MyBoat

ADDENDA VERSION 24V

MI00537-1-EN

WIRING DIAGRAM OF THE 24 V POWER SUPPLY

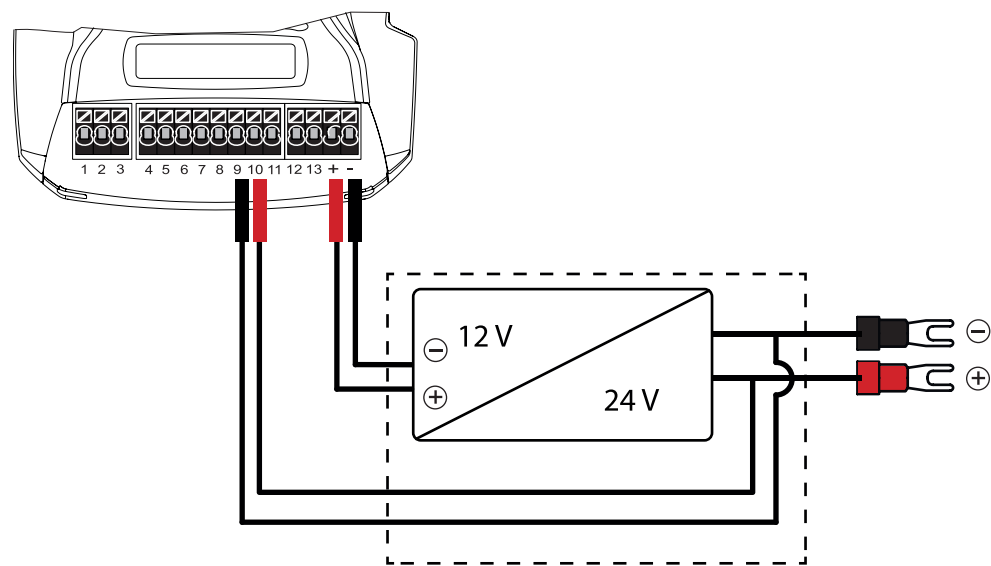
The power cables must be wired to the terminals as shown in the diagram above. If the wiring is not carried out according to the instructions, the control unit will be damaged.
